SR 360 WIDENING
CSSTP-0006-00(049) - P.I. No. 0006049
Cobb and Paulding Counties, Georgia

Value Engineering Study Report
Preliminary Design Stage

re: Project No. CSSTP-0006-00(049), P.I. #0006049
Widening of SR 120/Charles Hardy Parkway to SR 176/Lost Mountain Road
Value Engineering Study Report

ALTERNATIVE No. P-8
SHEET No. 2 OF 7

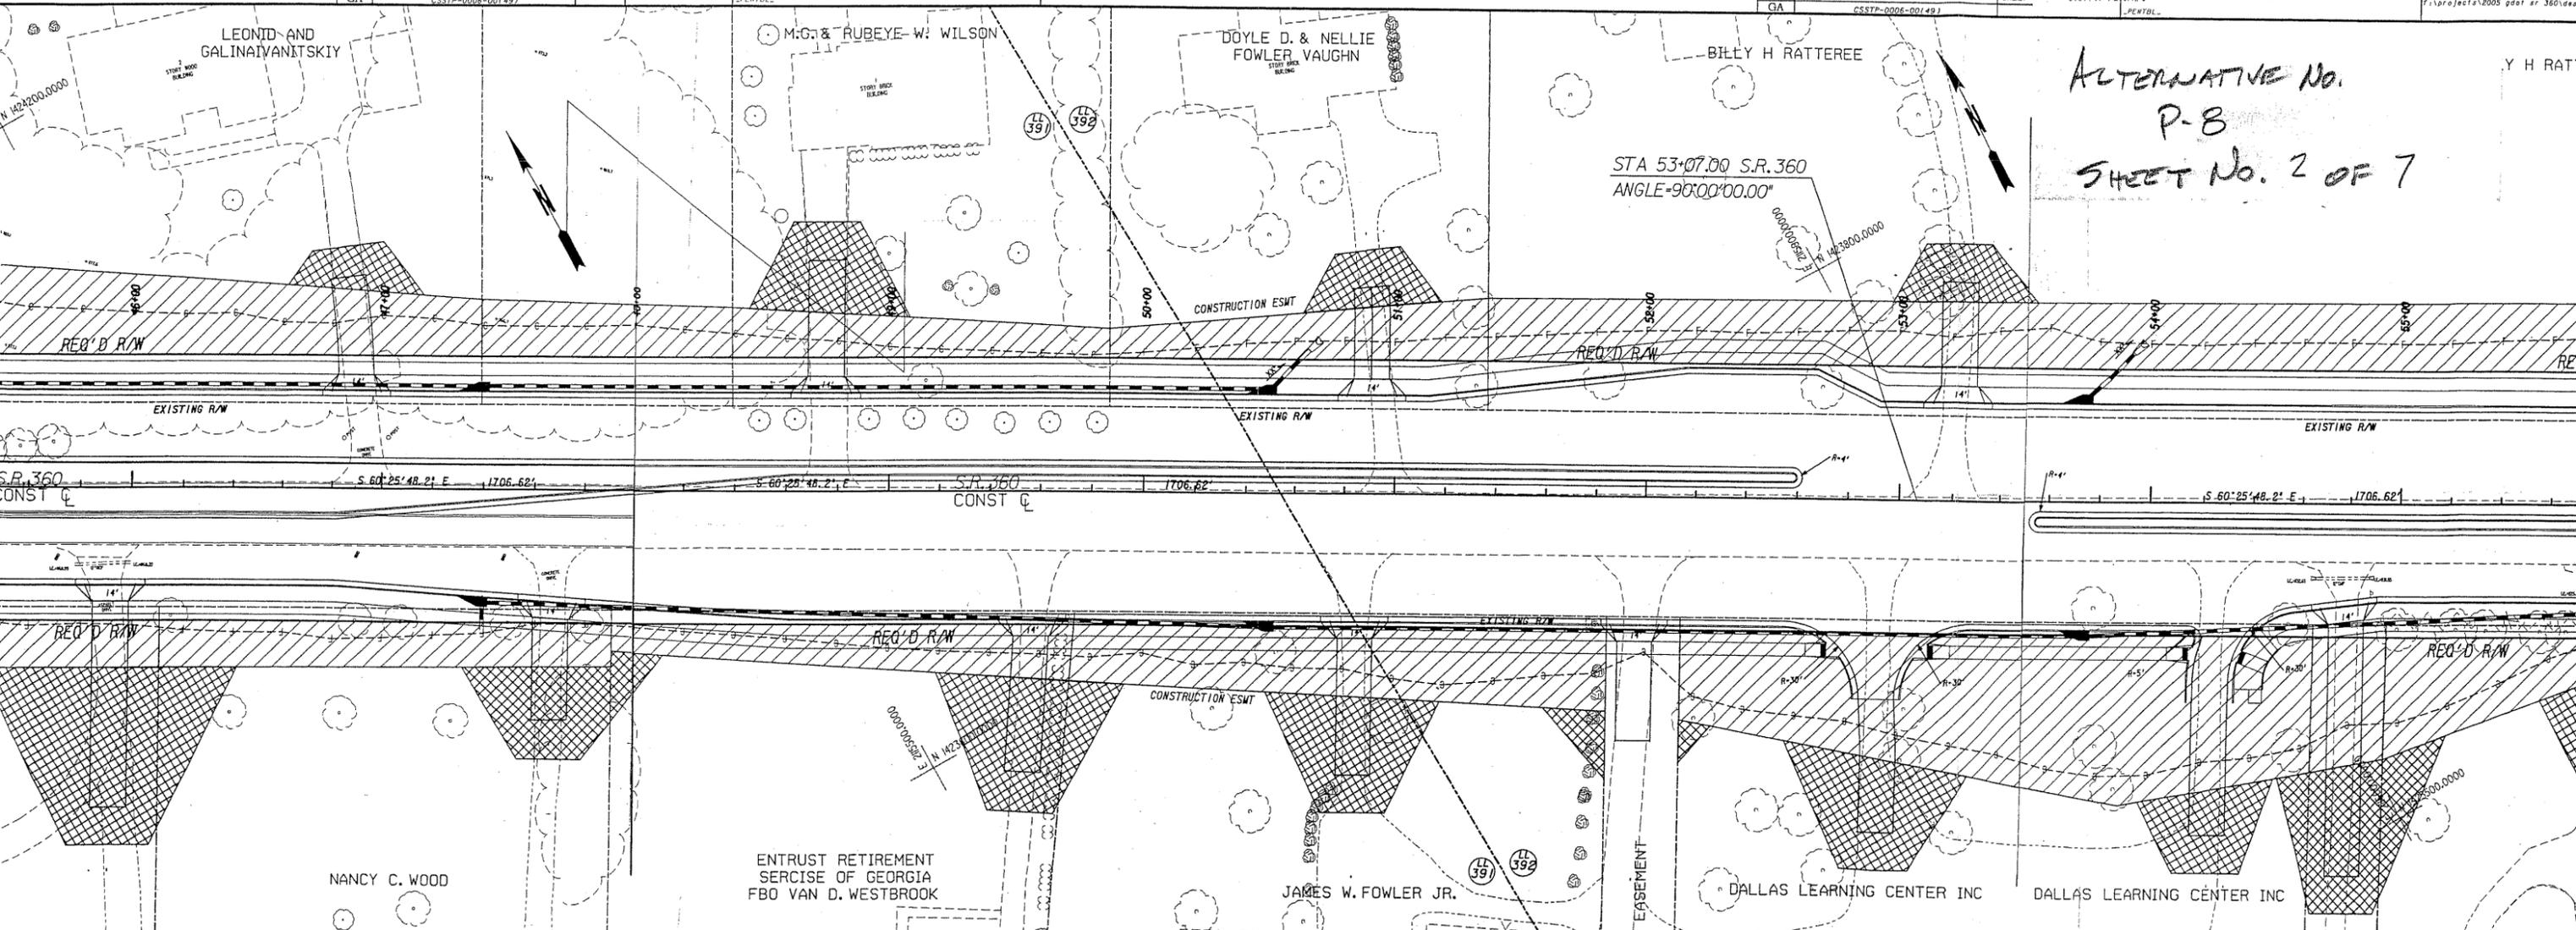
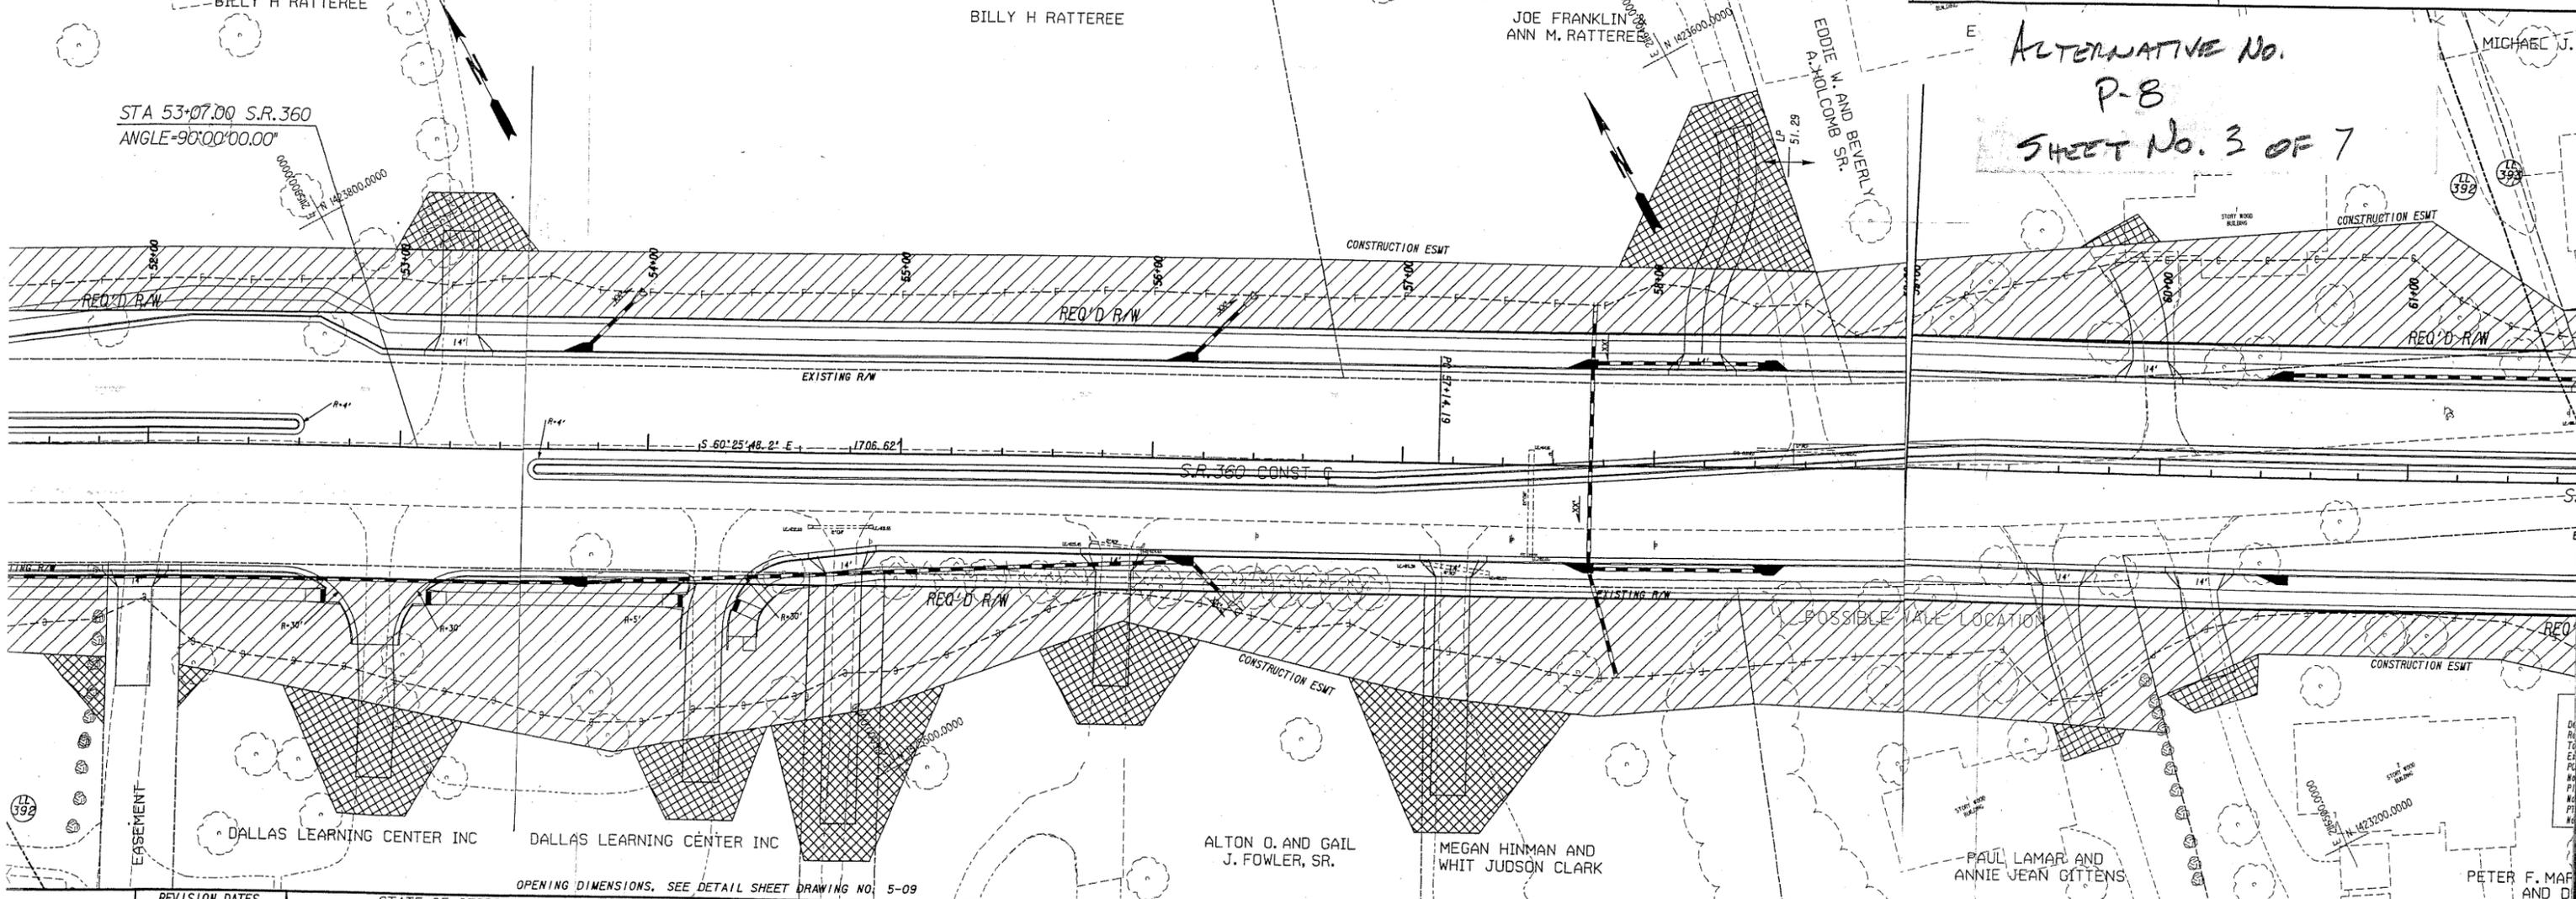
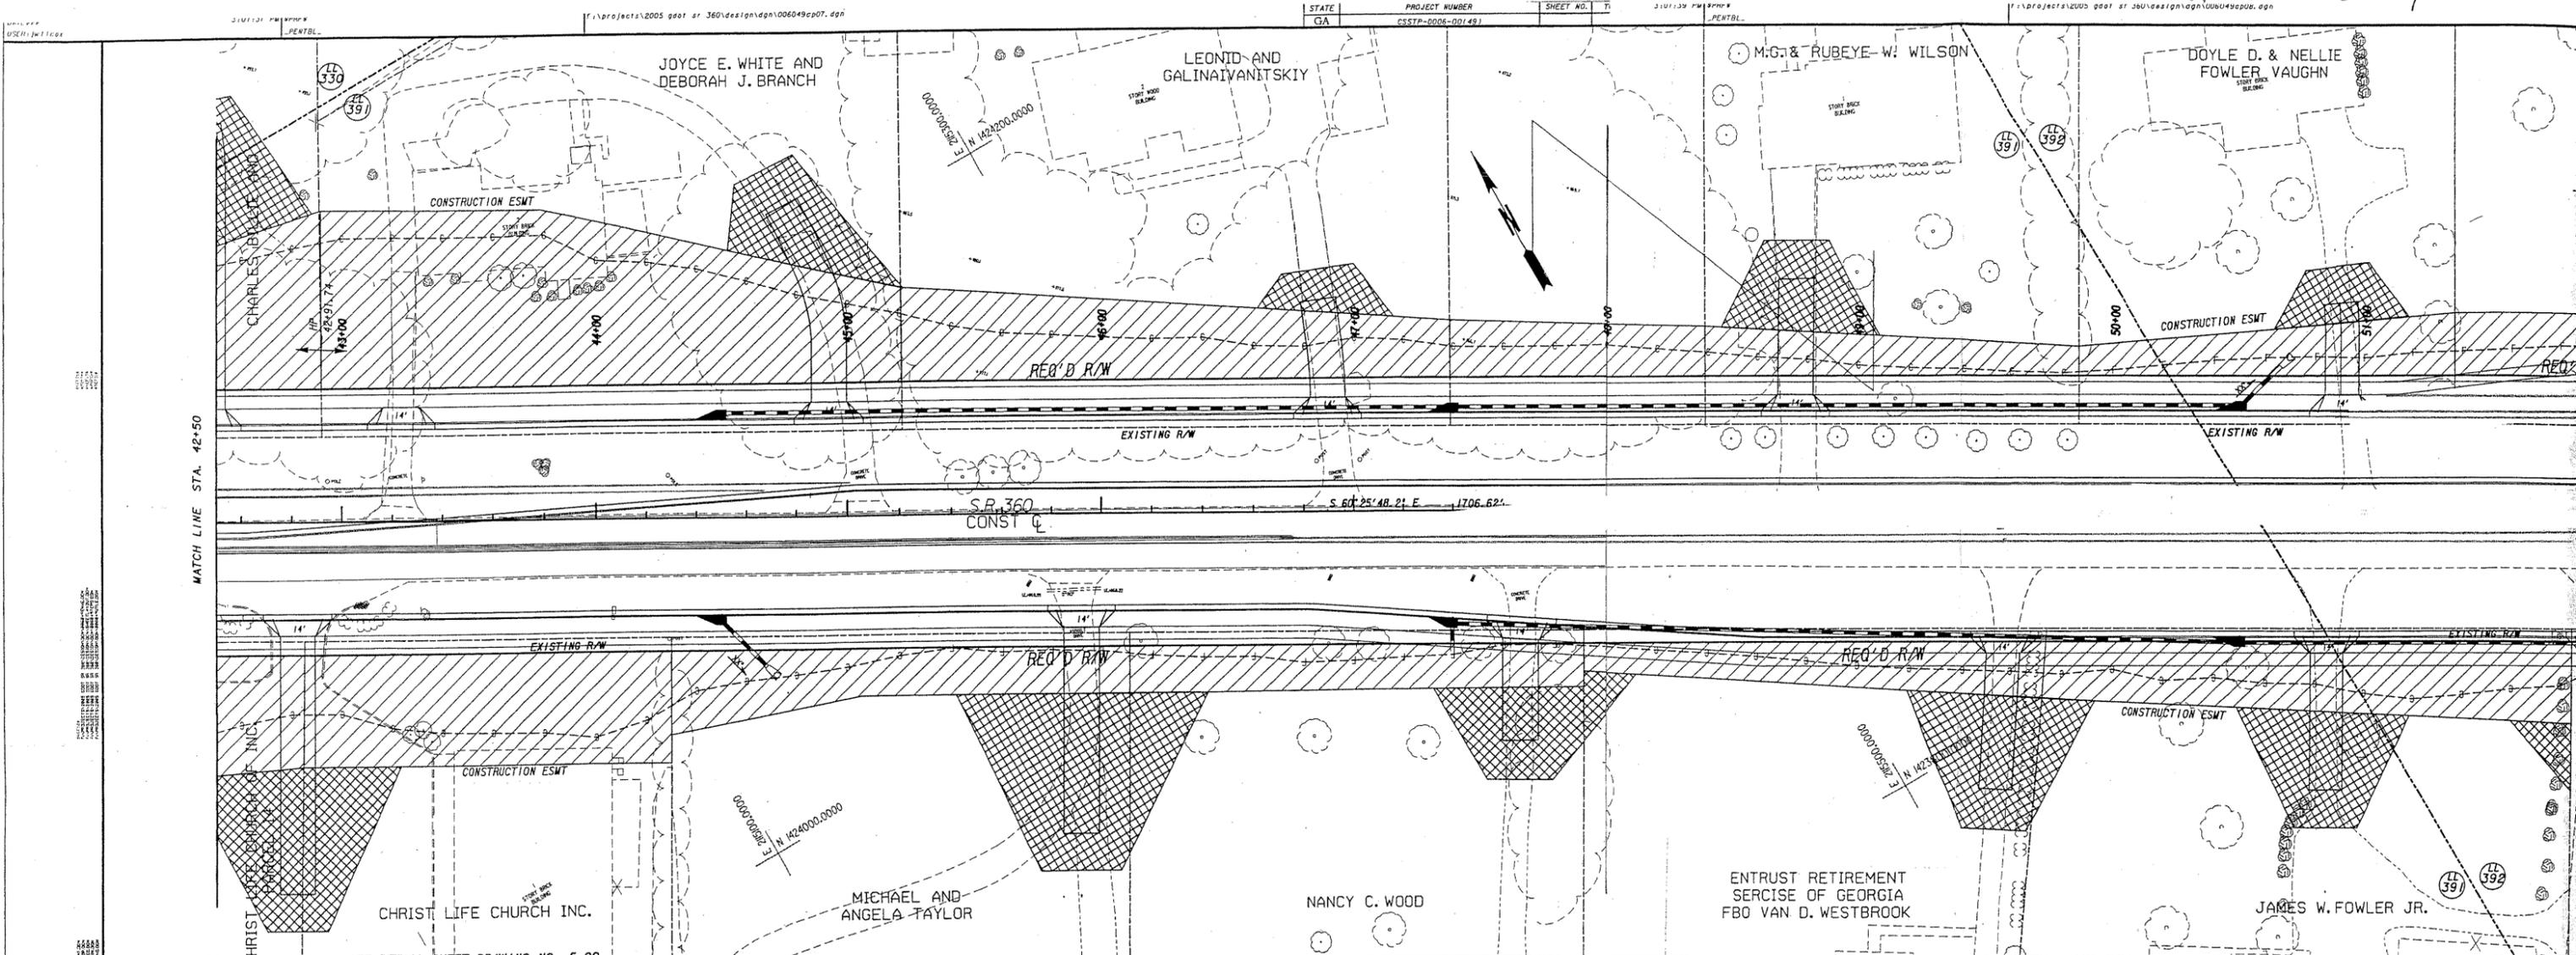
DESCRIPTION: **REMOVE U-TURN AT STATION 53+00**

Delete the U-turn at Station 53+00.
